50 Humberwood Boulevard - Zoning By-law Amendment, Draft Plan of Subdivision and Site Plan Control Applications – Request for Direction Report

Date:	October 27, 2016
To:	Etobicoke York Community Council
From:	Director, Community Planning, Etobicoke York District
Wards:	Ward 2 – Etobicoke North
Reference Number:	15 192495 WET 02 OZ, 16 133595 WET 02 SB and 16 133600 WET 02 SA

Attachment 1: Site Plan

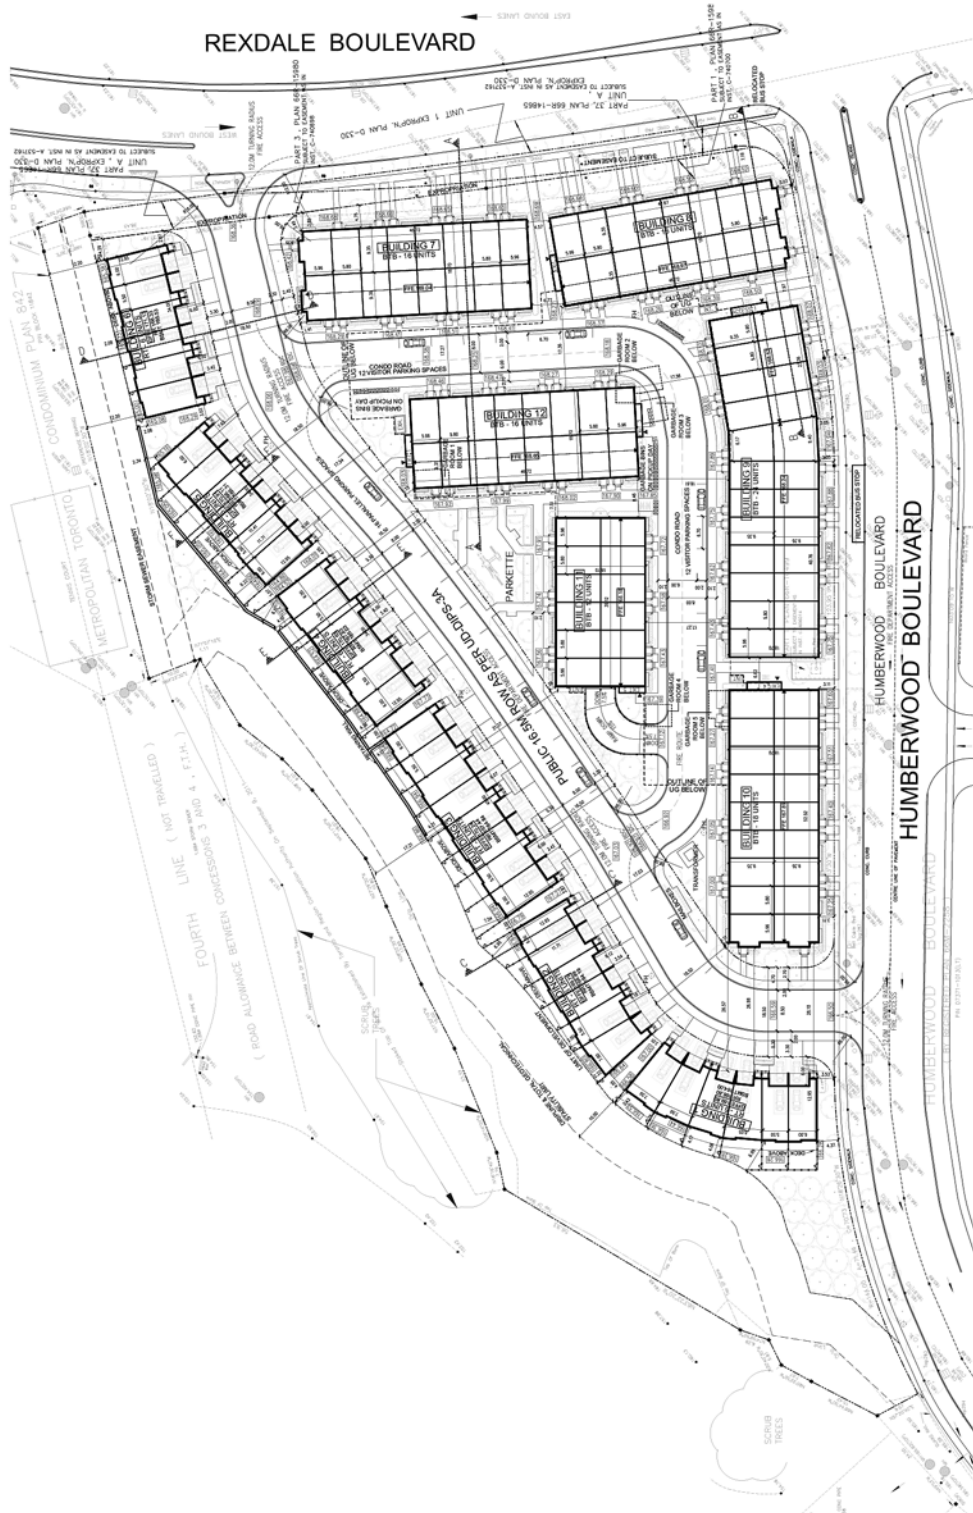
The layout and the location of the blocks incorporating end units that would face front units is inappropriate, as this would potentially result in units lacking light, views and constrained entrances. A more appropriate configuration of the blocks should be designed to respond to the opportunities and constraints of this site. In particular, the size and design of the buildings within the central block should be parallel to the public street to frame and support this street. Further, in preliminary discussions with the applicant, Planning staff noted concerns with the building separation distances between the blocks at the corner of Rexdale Boulevard and Humberwood Boulevard as well as the at-grade residential units fronting Rexdale Boulevard which are not compatible with this arterial road that supports significant commercial traffic. The proposed number and placement of the building blocks relative to the size of the development parcel would create undesirable conditions and poor relationships to the existing and proposed streets.

The proposed freehold street townhouse units on the east side of the new public street would have rear yard setbacks ranging from 2.09 m to 6.22 m to the ravine and Natural Heritage System. These setbacks would not provide adequate rear yard private outdoor spaces within this context, where a minimum setback of 7.5 m is appropriate. Townhouses with integral front garages should have a minimum lot frontage of 6 m wide. In the current proposal, some of the units would have a minimum lot frontage of 5.5 m wide. This would not provide adequate room for street trees, front yard landscaping, on-street parking and open space.

While the proposed development would provide the total vehicular parking supply requirements for resident parking, staff continue to have concerns with the proposed visitor parking for the back-to-back units. The proposal should be redesigned to reallocate some of the excess underground parking spaces for resident parking and/or additional visitor parking spaces should be provided on the private driveway.
